Section 131(6) Referral Response

I write in relation to the proposed development application for the *Construction of a new single-storey ambulance station with associated car parking and ancillary infrastructure*.

Section 131(6) Referral Response

Further to our initial response dated 7 July 2025, and in response to the revised submission from URPS dated 11 August 2025, Council provides the following comments:

Figure 2 Development location as shown in planning portal

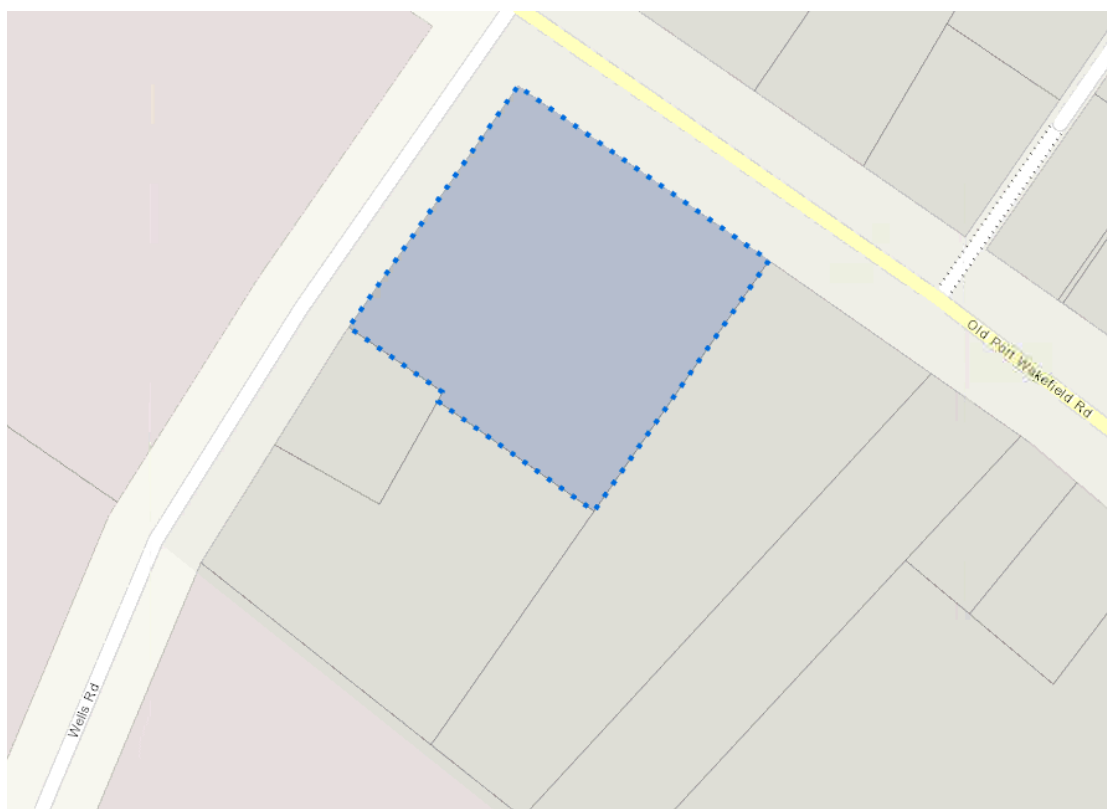
There appears to be confusion as to the actual site area for this application. Drawings submitted as part of this application show differing information, and the development location in the planning portal shows only a singular location, being Allotment 51 Plan Parcel D73399 (CR 6215/365) highlighted below.

The subject land does not appear to include the adjoining allotments to the south nominated and supported by Council for a future car park. This concern will be covered in further detail.

Figure 3 Application drawings show a new crossover and access from Wells Road going over a boundary of two allotments, one being under the care and control of the CFS.

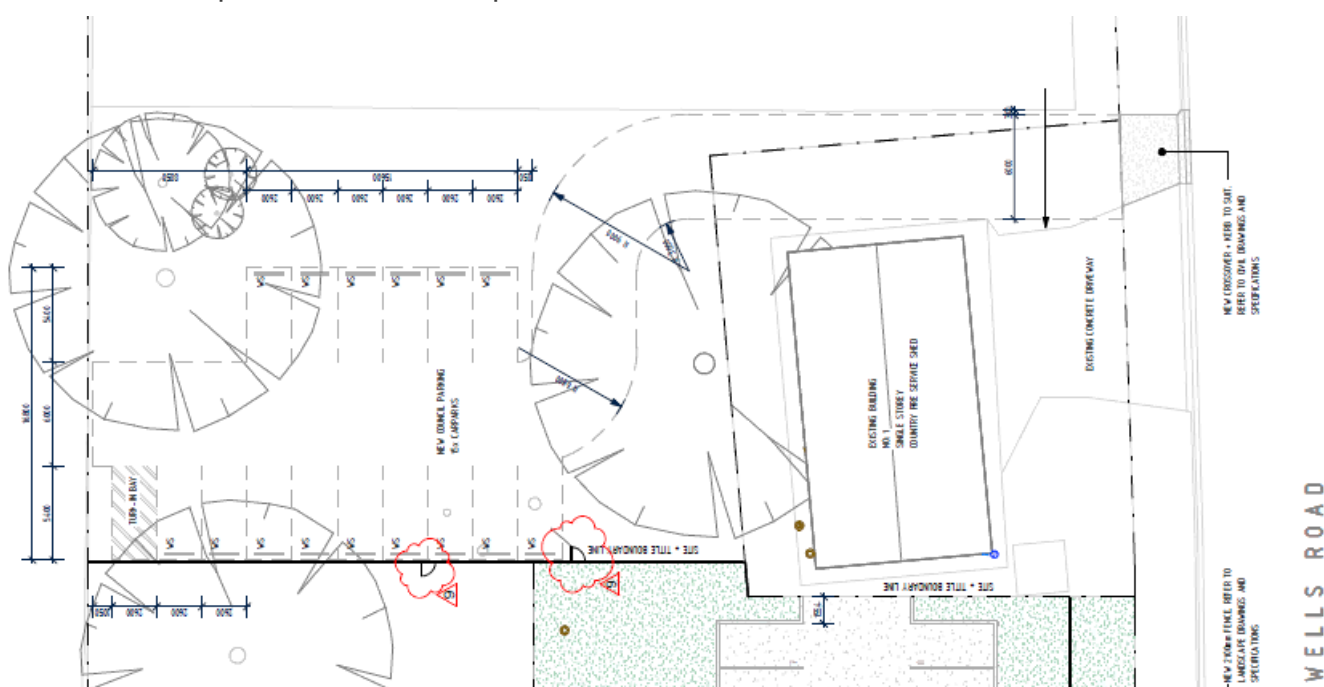
Whilst not technically part of this application, it is noted that the lodged drawings show a new crossover and access going over a boundary of two allotments, one being under the care and control of the CFS, to a car park with some 16 spaces. This needs more consideration.

Notwithstanding it is not included in this proposal, we provide the following comments on the proposed car park design shown on the adjoining allotment to the south.

The proposed carpark layout and design does not provide for sufficient space for the parking and maneuvering for the variety of vehicles and is isolated from the Service Centre building.

The existing car parking area and access point to Wells Road provides onsite parking for Council employees, for customers and visitors to the Council Service Centre, and access for Council maintenance staff with building infrastructure trade vehicles and trucks with trailers to maintain landscaped areas.

Movement of goods will be restricted to and from the Service Centre building as the rear of the site will be land-locked with no vehicular access from Old Port Wakefield Road.

The remoteness of a new carpark from the Service Centre limits passive surveillance of pedestrian movements. This aspect is exacerbated by the existing CFS building which further restricts surveillance from Wells Road and adjoining land.

Figure 5 Existing car park with blue building through the trees being Scouts

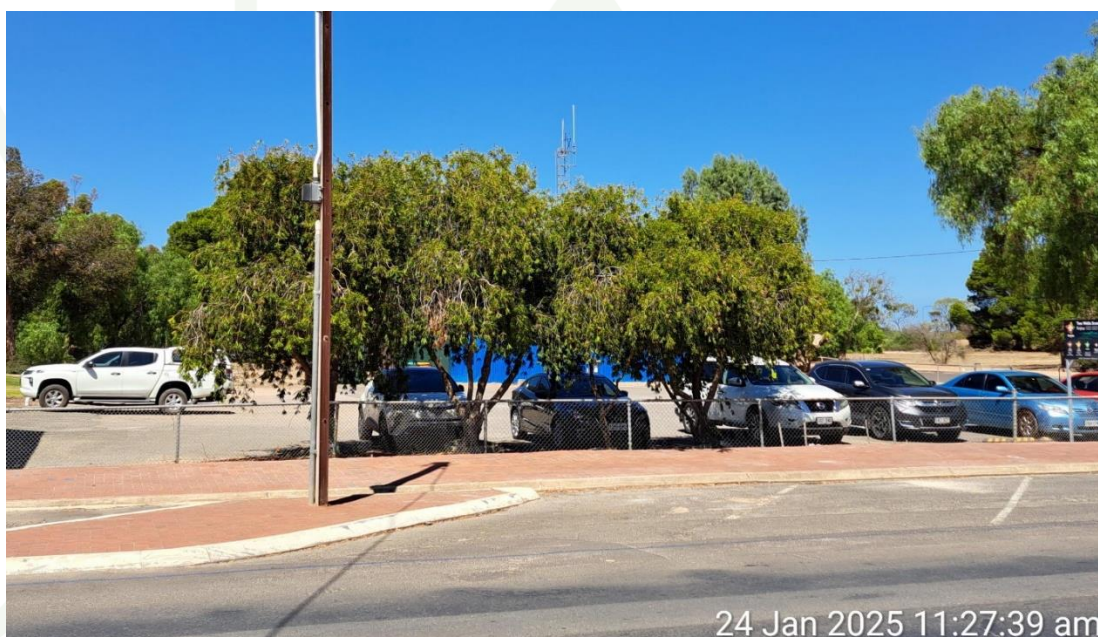
We question the existing car park servicing Council's Service Centre and the Scouts being referred to in the Traffic Impact Assessment as an 'unofficial parking area'. This is incorrect. The car park is sealed car park that is used by Council staff, visitors that attend Council's meeting rooms and offices, as well as the Scouts who have a lease on the site. To reiterate, Council has occupied the building known as the Two Wells Service Centre and the associated car park since the 1980s.
